ADDENDUM NO. 2

St. Vincent Greenway-187 Phase 1: Ferguson Ave, Great Rivers Greenway
Project No. - 220044
Federal Project No. STP-9901(666)

The construction contract for this project has been revised as follows:

DRAWING TITLE:
SOIL DETAILS

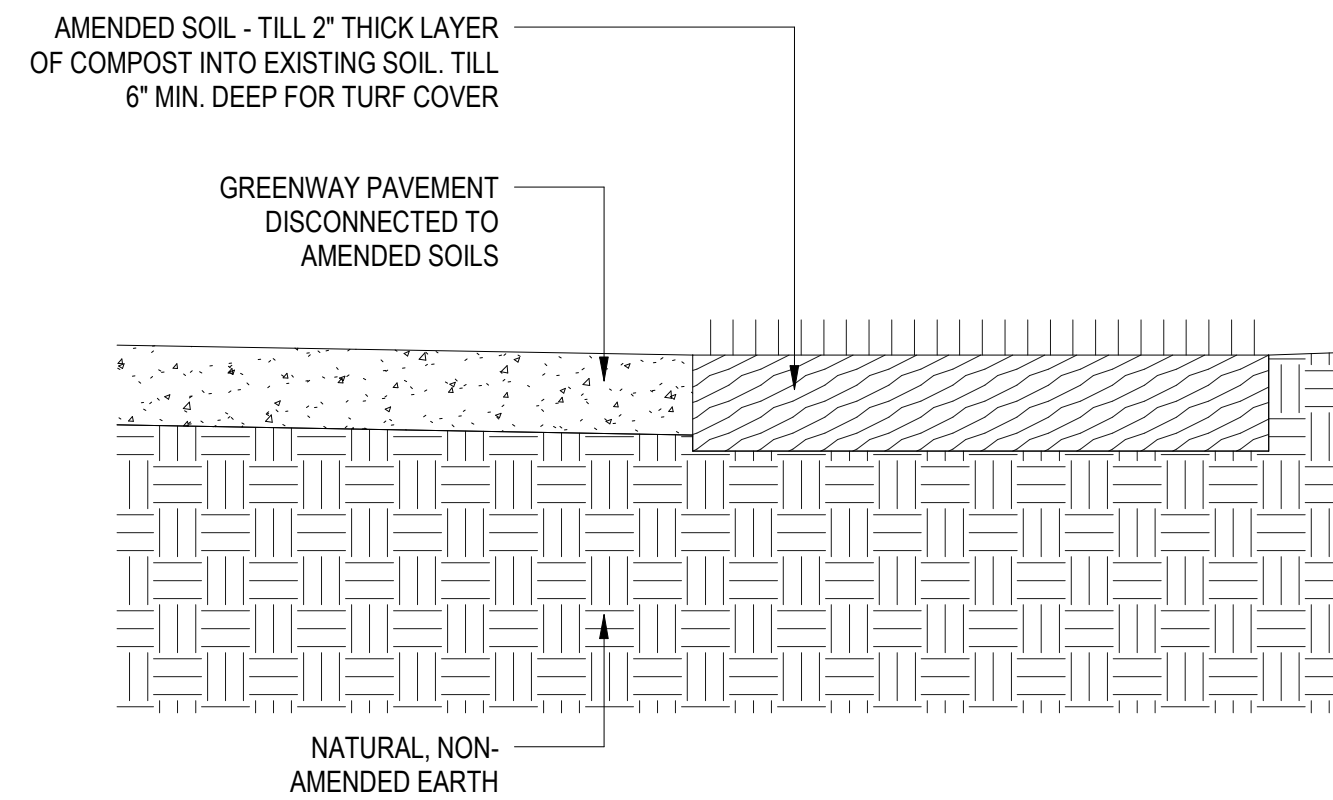
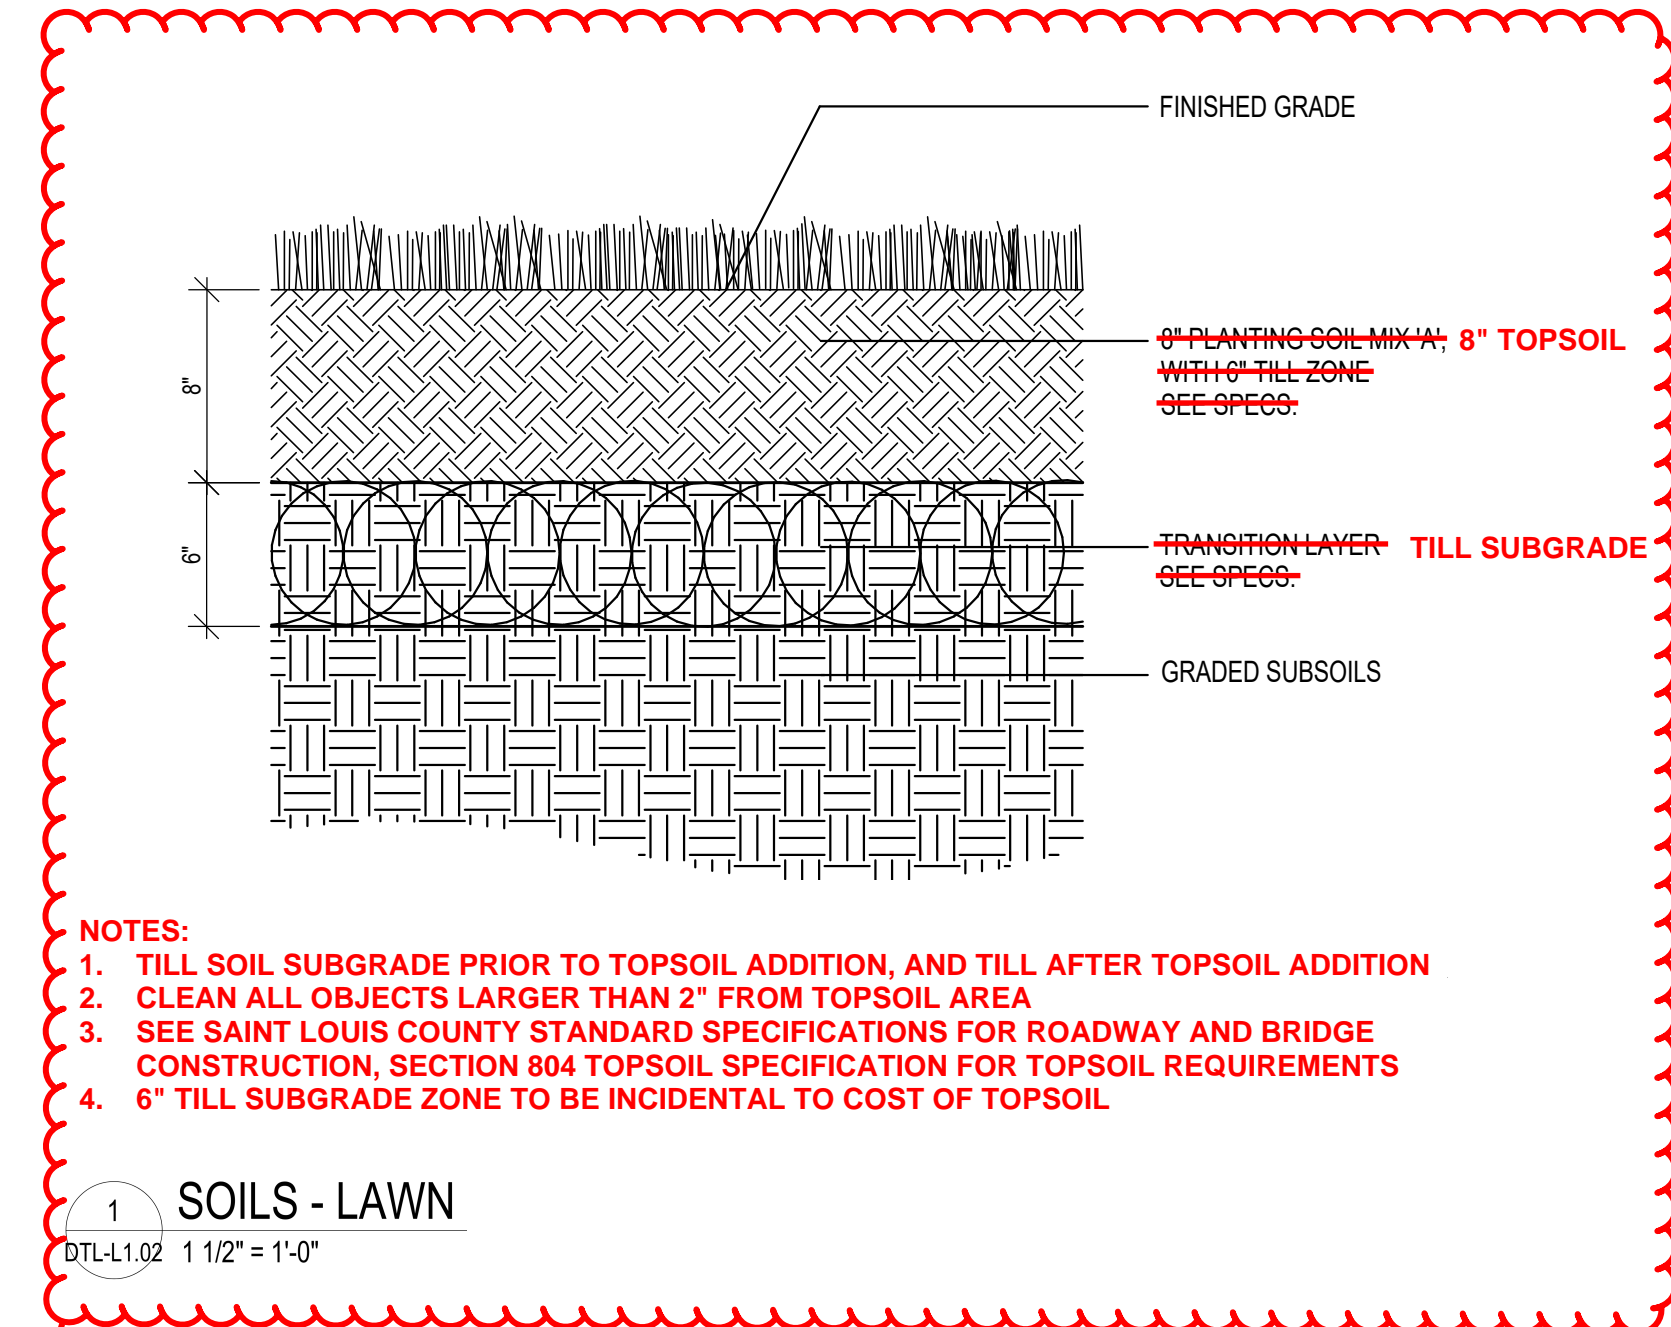
- Sheet 14 of 106 - Clarified “Soil Mix “A”” and “Transition Layer” by revising nomenclature to “Topsoil” and “Till Subgrade”. Notes detailing associated work and clarifying work incidental to other items have been added to Sheet 14 of 106.
- Revised quantities and locations for Pay Items Nos. 804-10.00 and 804-20.01 on Construction Plan Sheets Nos. 22 and 24 of 106.
- Clarify the nomenclature of Soil Mix “A” versus Topsoil. In this case the terms are being used interchangeably.
- Remove and replace Plan Sheet Nos. 14, 22 and 24 with the attached Plan Sheet Nos. 14, 22, and 24.

- NOTES:
1. TILL SOIL SUBGRADE PRIOR TO TOPSOIL ADDITION, AND TILL AFTER TOPSOIL ADDITION
 2. CLEAN ALL OBJECTS LARGER THAN 2" FROM TOPSOIL AREA
 3. SEE SAINT LOUIS COUNTY STANDARD SPECIFICATIONS FOR ROADWAY AND BRIDGE CONSTRUCTION, SECTION 804 TOPSOIL SPECIFICATION FOR TOPSOIL REQUIREMENTS
 4. 6" TILL SUBGRADE ZONE TO BE INCIDENTAL TO COST OF TOPSOIL

3/7/25 BY JMD (STL) APPROVED BY BRR (STL): CLARIFICATION AND ADDITIONAL INFORMATION REGARDING TOPSOIL AND AMENDED SOIL
